GROVE LODGE PLANNING PROPOSALS

Grove Lodge
Admiral's Walk, Hampstead
London, NW3 6RS

Grove Lodge, Hampstead - Briefing note on amended scheme

Appendix B – Technical Responses

Figure 1: Section through boreholes – perched water levels

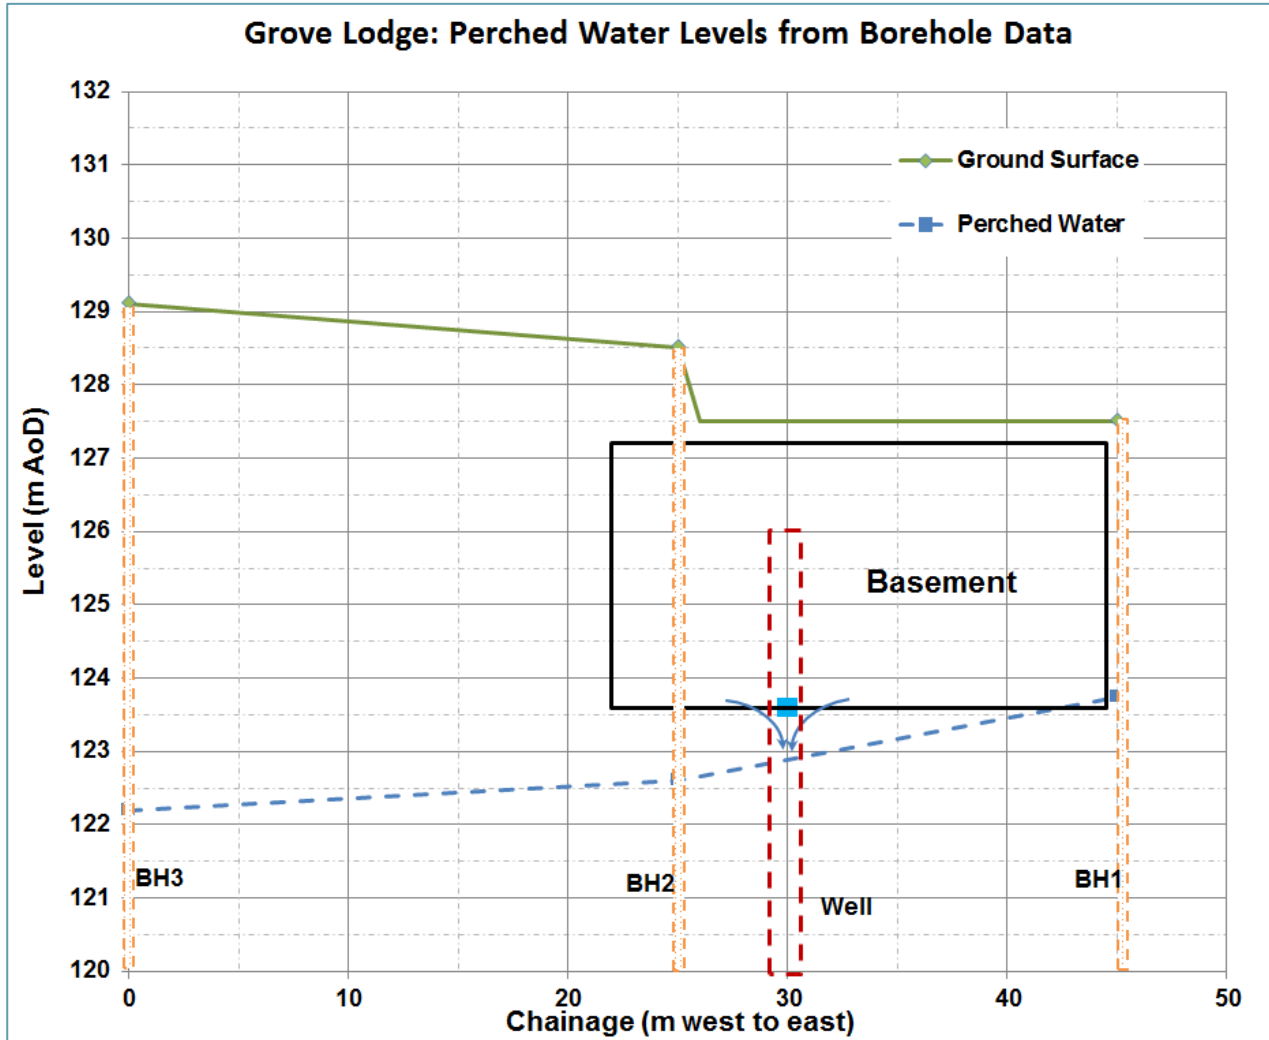
The criticism appears to be on the basis that given the nature of the Bagshot Formation there might have been perched water at higher (or lower) levels at the boreholes. The concern appears to be that if there was water entering at several levels a single piezometer in each borehole would not have given full information on groundwater levels and might “average” out some groundwater levels. However, there was no such evidence of multiple levels of perched water observed at the boreholes. Whilst some of the ideas discussed seem quite plausible there is not the evidence to show that they apply at this particular location.

We have always taken account of the evidence of stratification and variability in soil conditions. In doing so we have still concluded that there is no evidence from the site investigation that a significant depth of groundwater exists above the base slab at the site

An indicative section from BH3, to BH2 and then to BH1 is given as Figure 1. This depicts the approximate ground levels and the typical recorded levels of perched water (whilst linked by a dashed line for clarity, it is recognised that in practice this is indicative only, with the actual levels depending on the local soil conditions, rainfall, etc. They may not vary linearly).

The approximate level of water entering the side of the well is also shown on Figure 1. This location is set back 15m to 20m from the line of the section, and thus one would normally anticipate a slightly higher groundwater level at the well than along an adjacent point on this section.

Based on the 2.5m depth down from the top of the well, we estimated that the perched water level at the well is at a similar level to BH1 and about 1m higher than at BH2 – see Figure 1. We concur that the general observations from the well support the concept of perched water – as observed at the boreholes – and the approximate levels. A more accurate assessment is not possible with the information currently available.

Figure 2: Groundwater levels – borehole 1

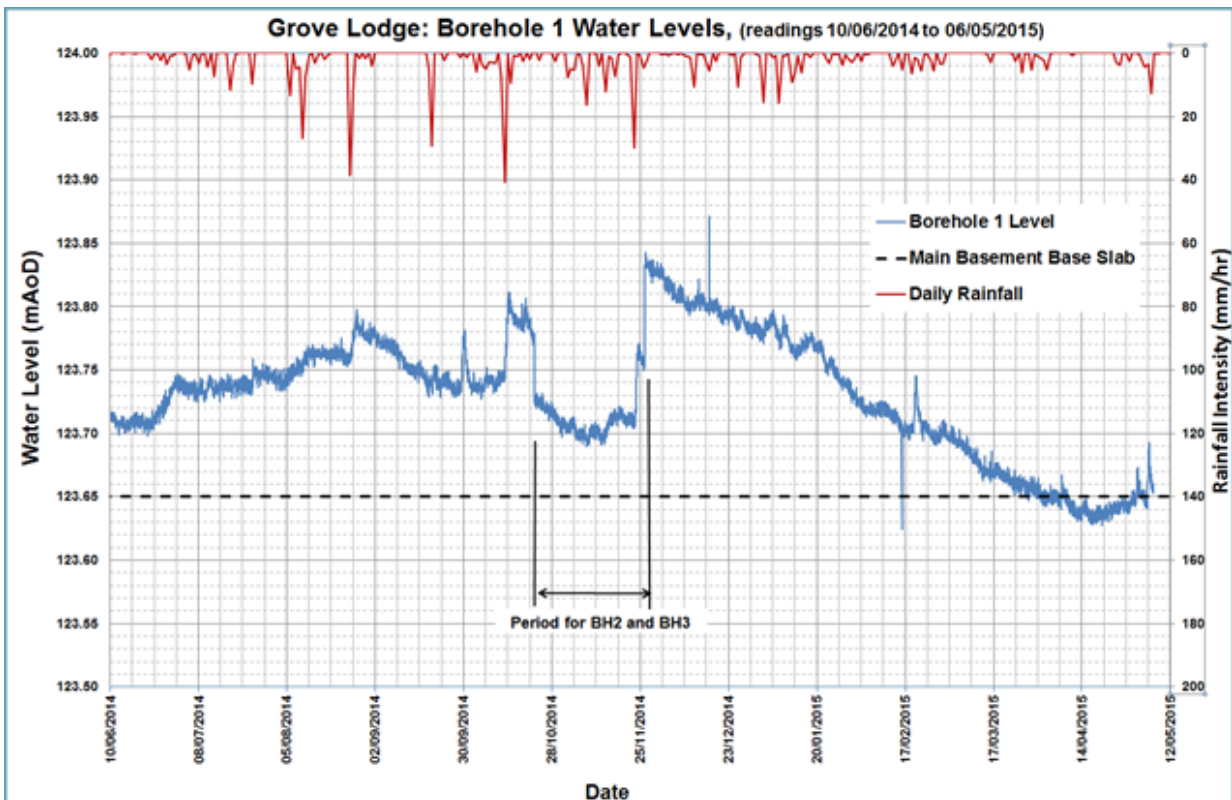
In the Admiral's House response it says "it is not surprising that only a much subdued reflection of rainfall is seen in this record." It then links assumptions on the rainfall response and consideration of the soil porosity to the explanation of the sudden changes in water level at BH1, which was assumed to be related to the drilling of BH2 and BH3 – see above for an explanation of the error in this assumption.

HR Wallingford has compared daily changes in the recorded water level at BH1 to the rainfall over the previous day and in fact there is a clear depth increase when there is a significant amount of rainfall - see Figure 2. Whilst the change in depth is small the response is quick. It is certainly not "subdued", as described in the Admiral's House response.

Thus, it is clear that the Admiral's House response is wrong in various assumptions related to the changes in groundwater levels and the response to rainfall. This has resulted in some incorrect conclusions. This is probably through having insufficient local groundwater level and rainfall data available. We have sought to explain the situation through reference to more detailed information.
